STAFF REPORT

NEW BEDFORD HISTORICAL COMMISSION MEETING

July 11, 2016

LOCATION: 18 Johnny Cake Hill (Map 53 Lot 161)

**VIEW FROM
WILLIAM ST. & JOHNNY CAKE HILL**

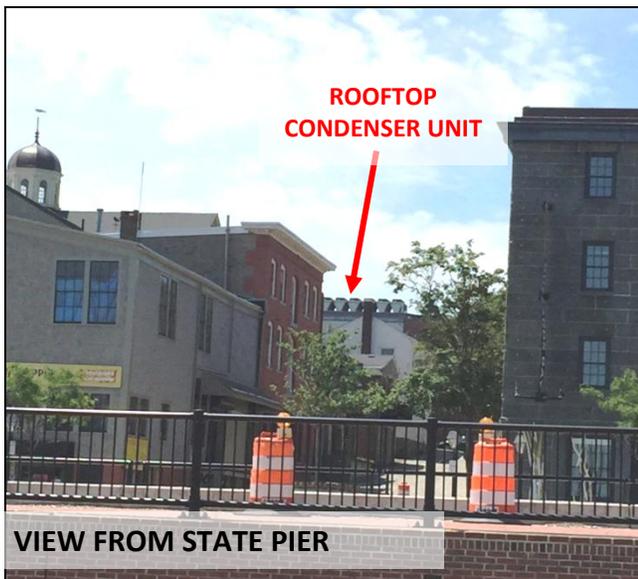
STAFF RECOMMENDATION: The proposed use of lead coated copper for the proposed screening appears to be related to the previous use of that material on the Whaling Museum theatre’s east and north façades. Although introduction of a lead coated copper screen has been incorporated into the roofing at the north/north east face of the Jacob’s Gallery theater, it is not within the visual sightlines of the condenser unit. As such, lead coated copper screening for the condenser units in this case may not be the most appropriate material for screening.

Instead, the use of brick for screening appears to be a better choice of material, due to its existence on the Wood Building, the Bourne Building and the theatre, and in light of both its compatibility and consistency with materials within the immediate sightlines of the condenser unit.

In light of this, staff recommends the use of brick for the screening material to address the sightlines from William Street/Johnny Cake Hill, but urges the Commission to solicit information from the applicant concerning more detailed specifications related to the color and type of brick, height of screen, distance of setback, coping material and the extent to which the screening material will be used (whether it is intended to encompass the entire condenser unit or just the portion which is visible from William Street).
